Multiple Sewershed Package 14 – Open Cut and Pipe Bursting
Solicitation No.: CO-00365
Job No.: 19-4545

ADDENDUM 4
October 19, 2020

MAP No. 000-000 SHEET 19 OF 19
 SECT. No. _____
 DR. JEM CK. JGM JOB No. _____

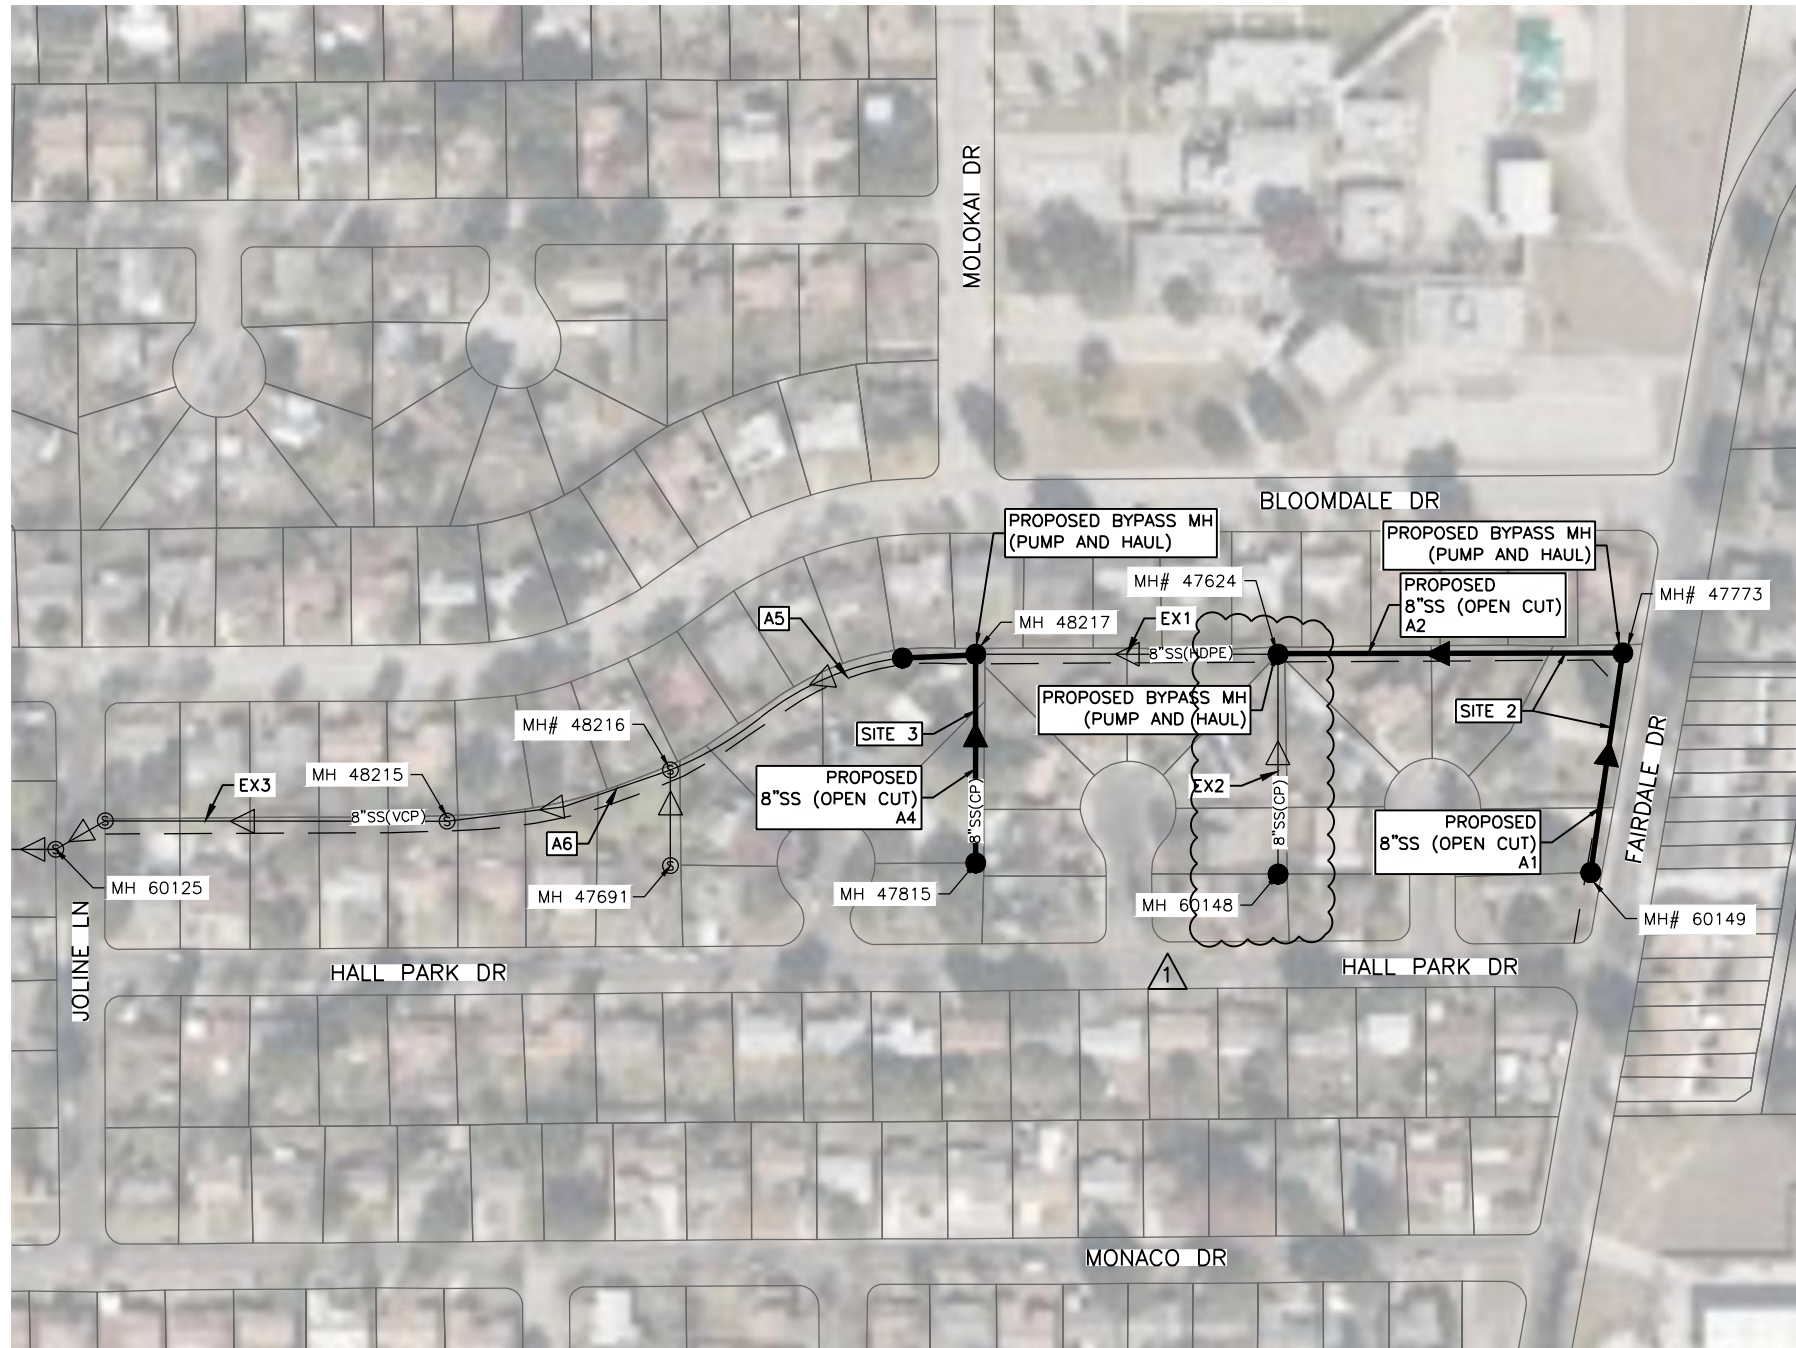
2. Sheets 2, 7, 10, 19, 20, and 21 were revised to indicate the removal of Site 4 from the project.
3. The following updates have been made to the Summary of Quantities on Sheet 5:

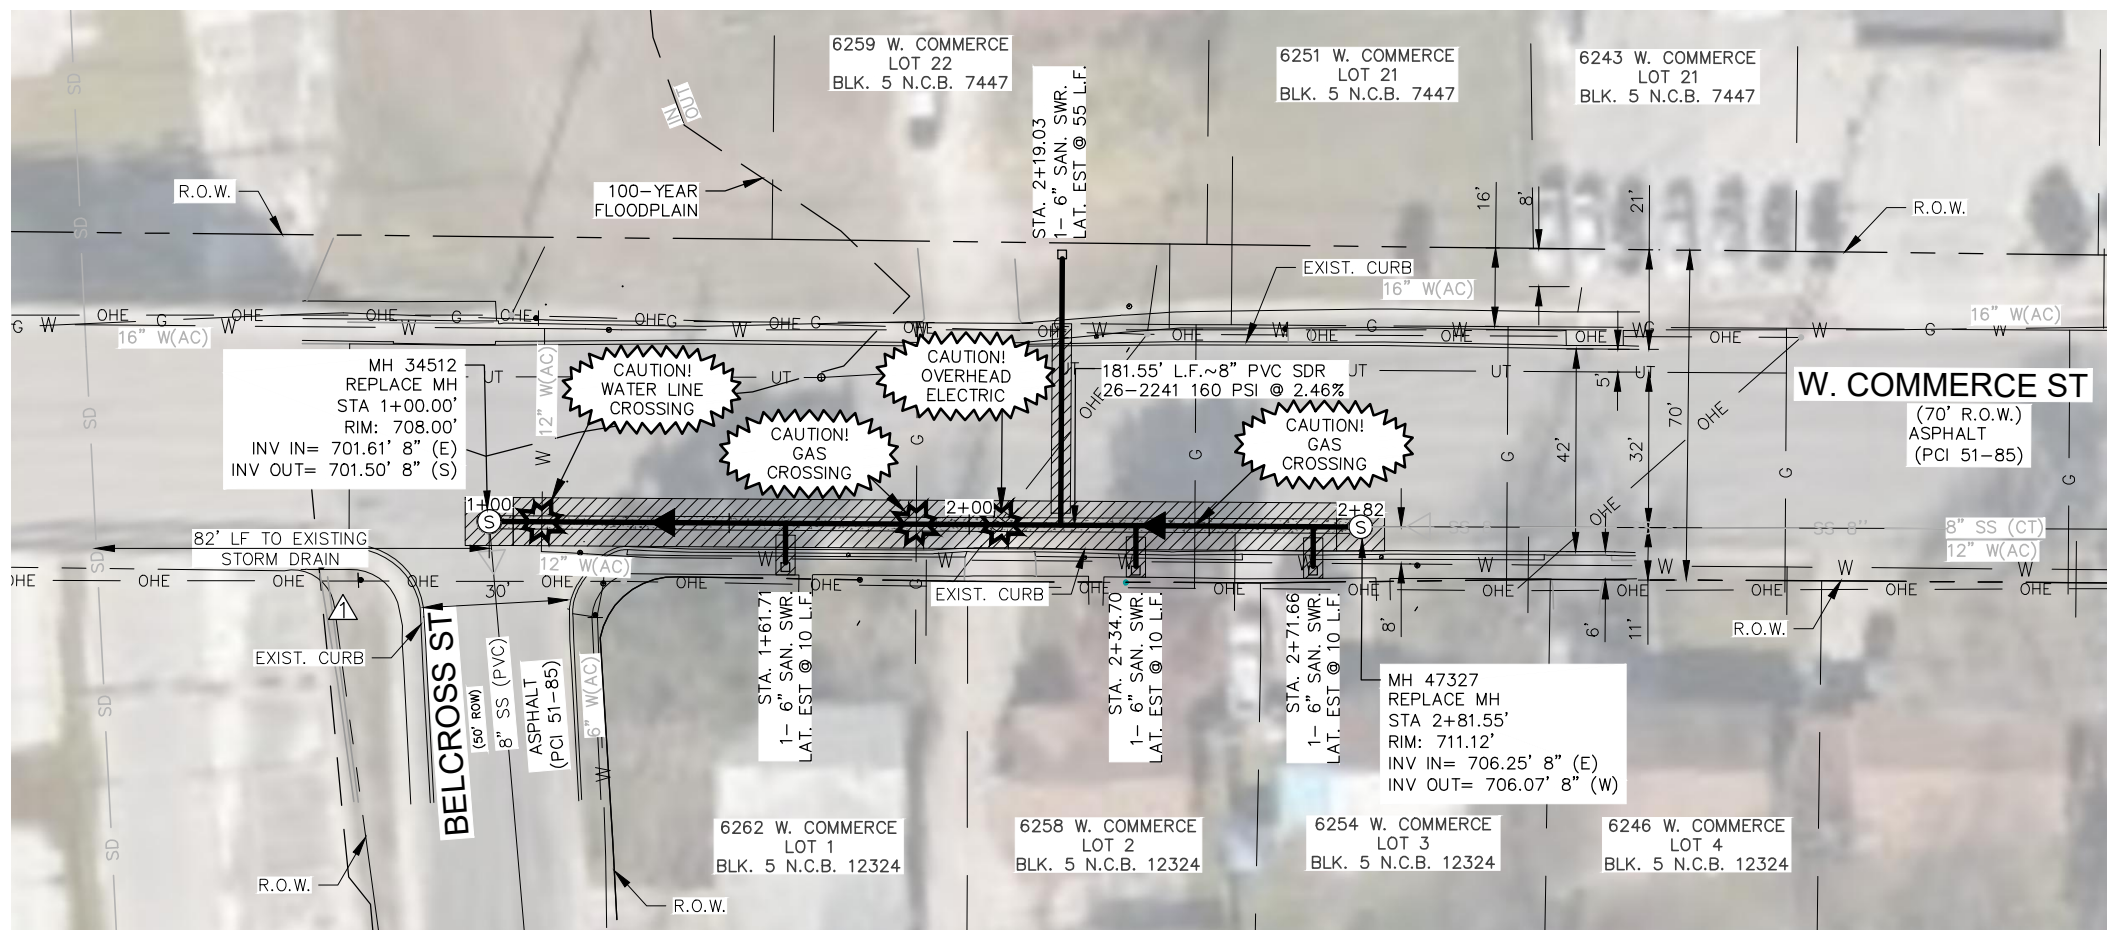
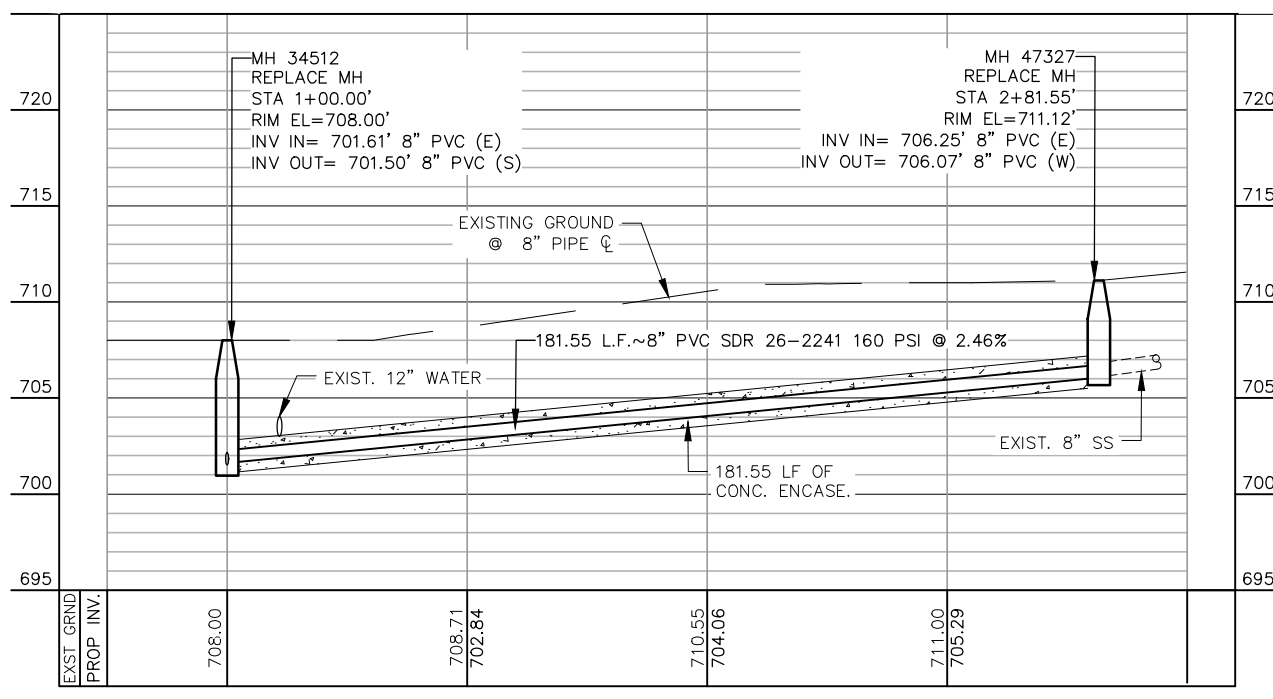
8. Sheet 22 was revised to update quantity and the payment unit of Bid Item 6001 Portable Changeable Message Sign.

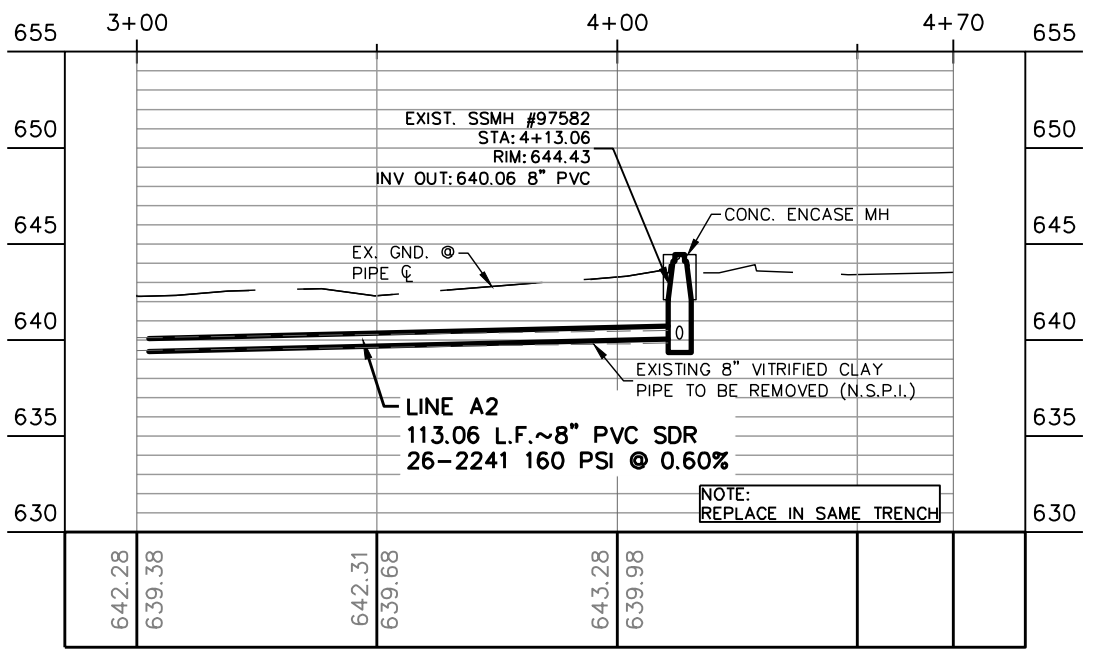
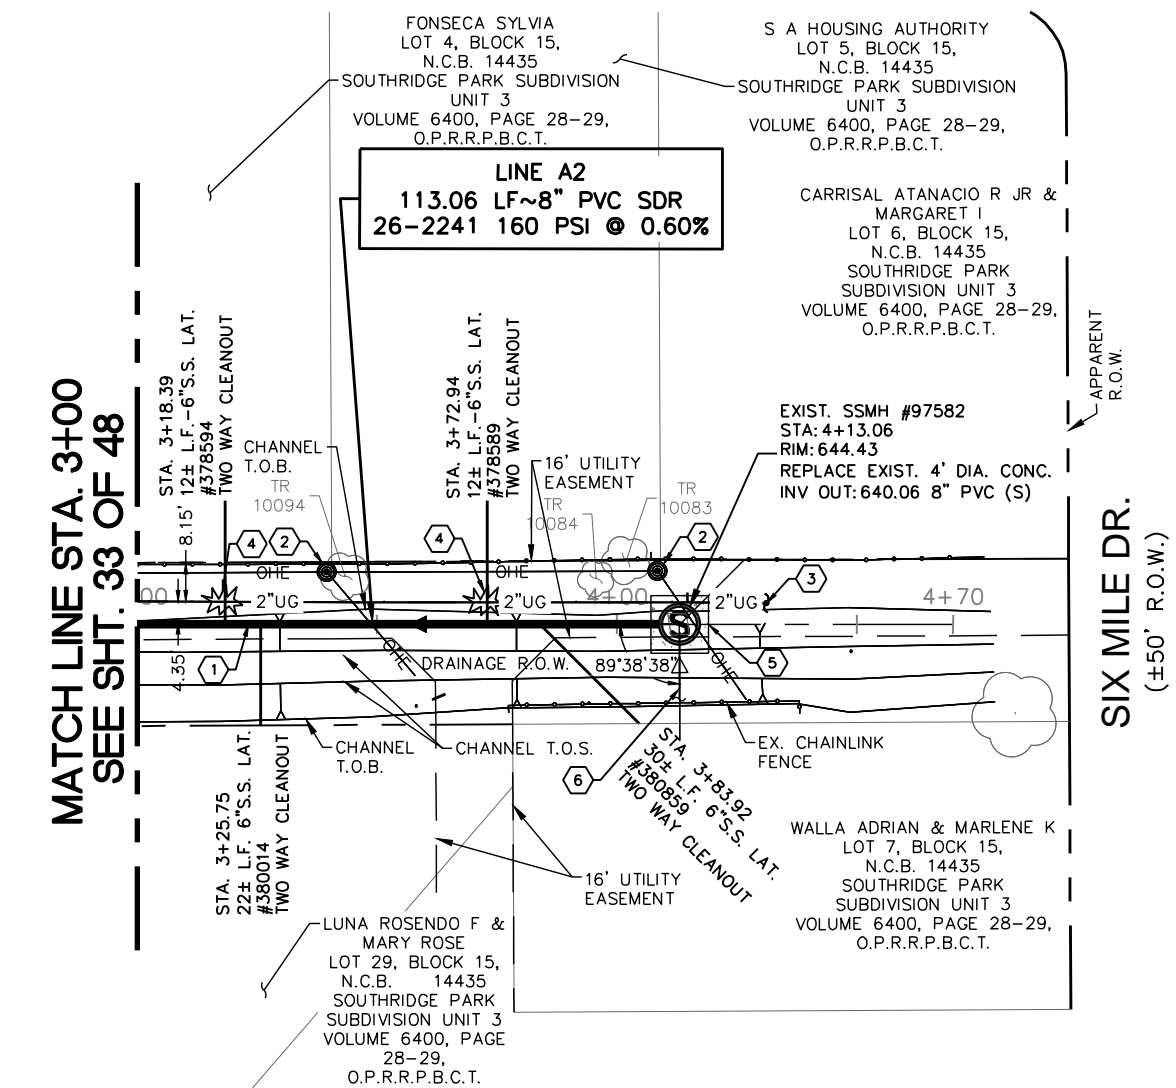
7. Sheet 34 was revised to update Tree Table.
